ADDENDUM NO. 1 DATED 7/19/2016 ADDENDUM NO. DATED
 ADDENDUM NO. DATED ADDENDUM NO. DATED

Number	Description
1	Revised Table of Contents; Add SP 907-619-12; Revised Bid Items; Amendment EBS Download Required.

MP-2035-04(011)/ 305880301000

SPECIAL PROVISION NO. 907-619-12

Detail of Temporary Portable Rumble Strips

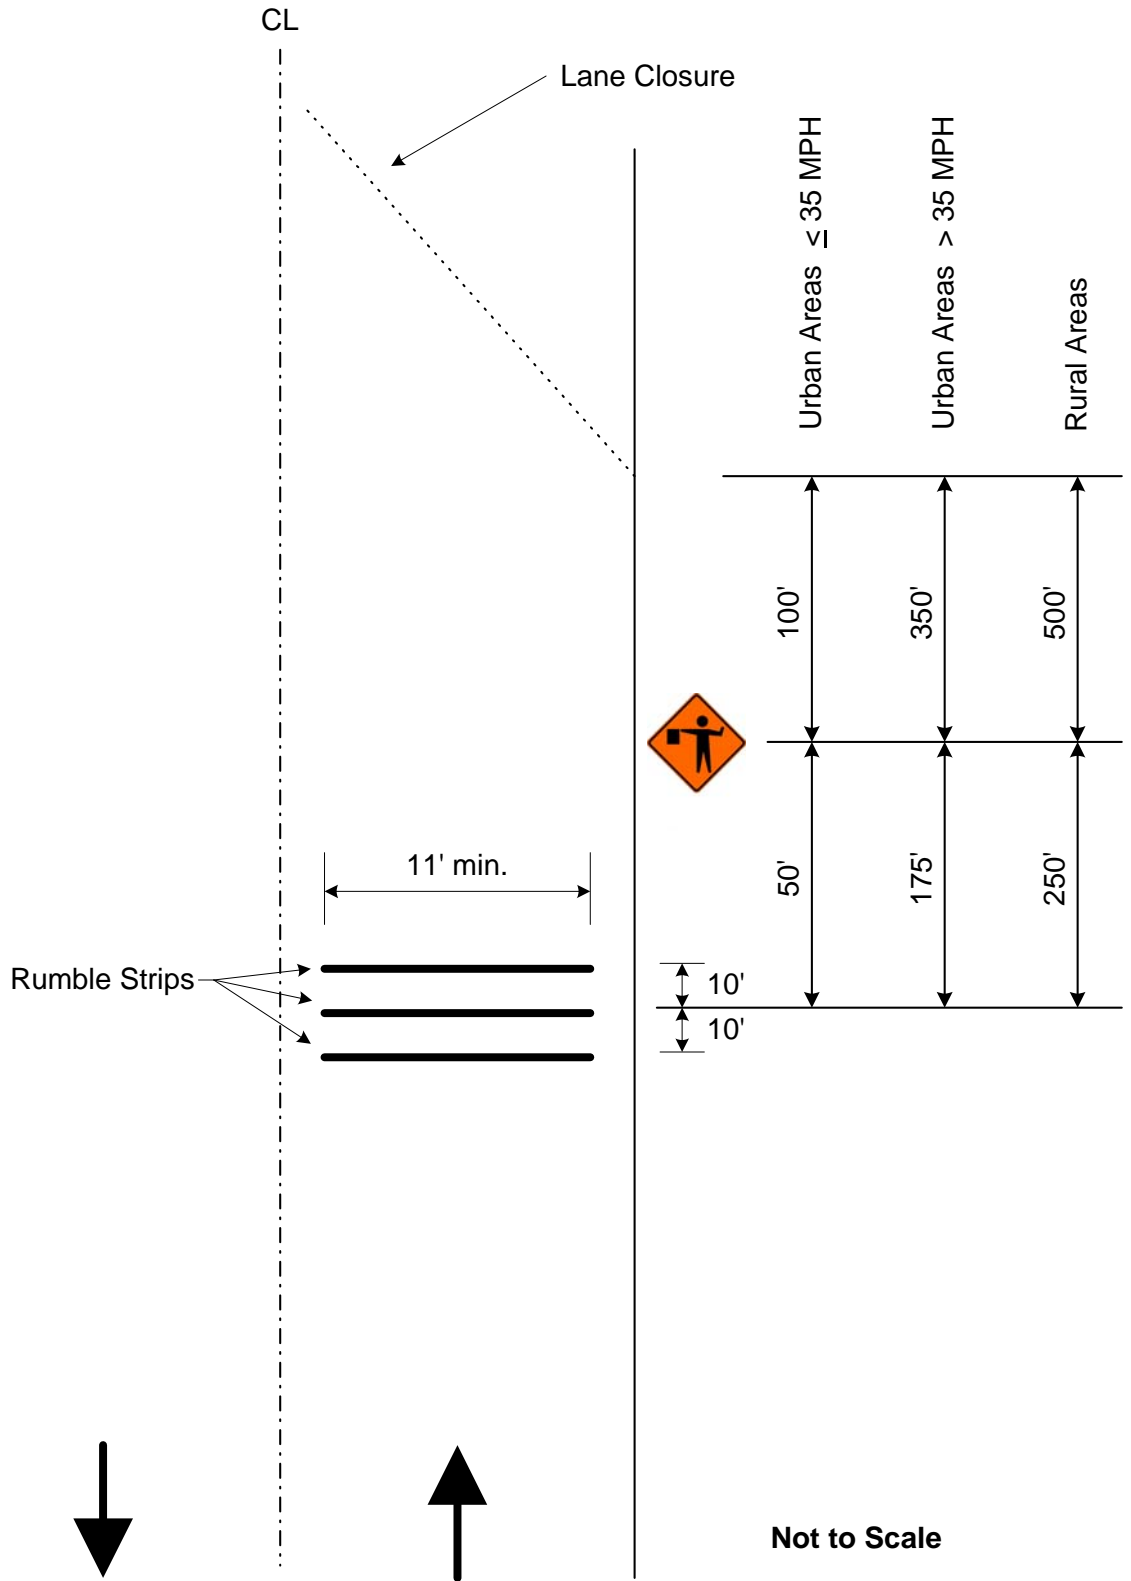
907-619.02.16--Temporary Portable Rumble Strips. Temporary portable rumble strips shall be made of engineered polymers and may be composed of interlocking segments or may have a hinge at the midpoint. The rumble strips shall consist of the following:

- capable of being installed without adhesives or bolts,
- have a minimum weight of 100 pounds,
- have a minimum overall length of 11 feet,
- have a minimum width of 12 inches, and
- have a maximum height of 3/4 inch.

Temporary portable rumble strips shall be installed in accordance with the attached details, or as directed by the Engineer.

907-619.03.12--Temporary Portable Rumble Strips. Temporary portable rumble strips shall be placed at locations shown on the traffic control plans, attached drawing, or as directed by the Engineer. The rumble strips shall be removed when lane closures are removed, relocated when lane closures are relocated, or as directed by the Engineer.

A minimum of three (3) temporary portable rumble strips shall be arranged in an array. The spacing of temporary portable rumble strips in each array shall be on 10-foot centers. The rumble strips shall be regularly monitored and maintained to ensure they stay in place under traffic.
